## ADDENDUM ONE (1)

RE: RFP #735-19-8218 New Museum Monument Sign

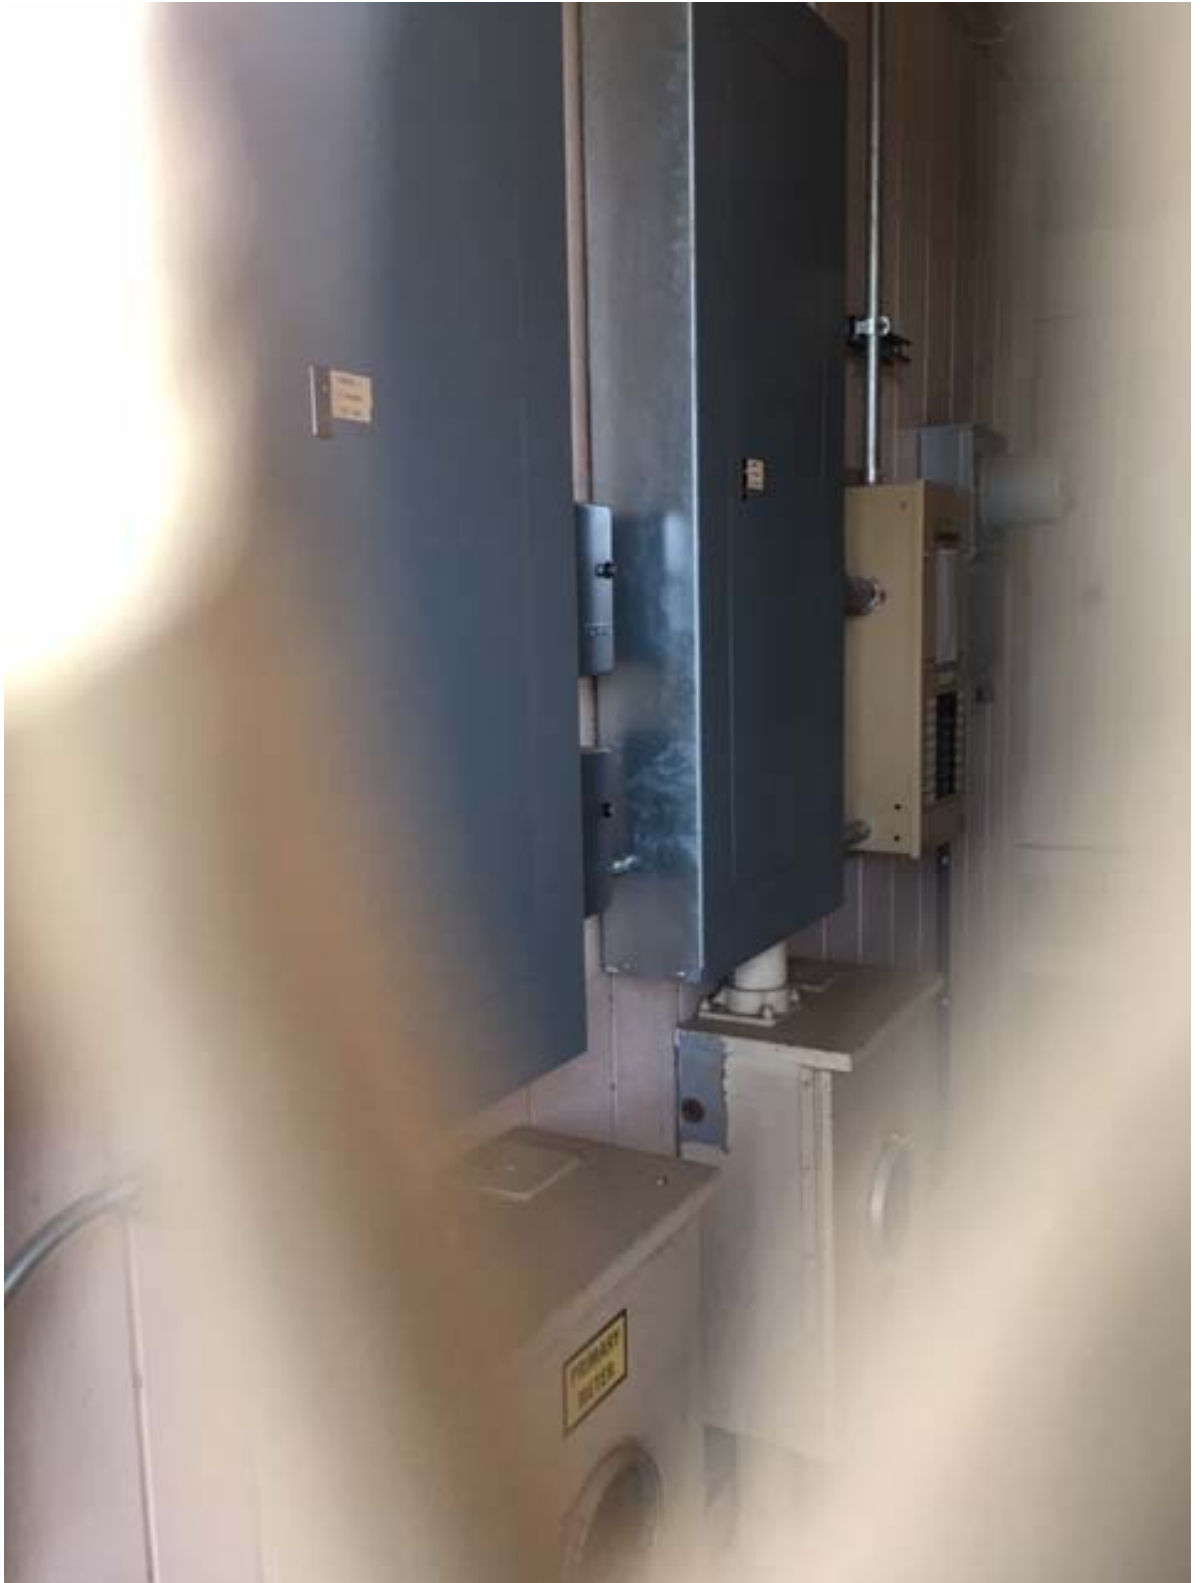
- Did you have a set start date for construction in mind? **Start when PO is issued ideally, but not overly critical**
- Would you please tell me what the estimated cost range for the above project is?  
**Cost is estimated to be \$50-\$60k (?).**
- Is the electrical room directly on the other side of the outside wall where they show the circuit coming from? **Building's electrical panels are on the west side of the building shown with a bump out on the drawing. This area is actually outside of the building and there is a sidewalk in this area. See photos below.**

**IMG\_9803: Caged area on west side of UPD.**

**IMG\_9804: Existing conduit entrance from ground into caged electrical area.**

**IMG\_9806: Electrical panels inside caged area.**

**IMG\_9808: West side view of UPD and caged area.**
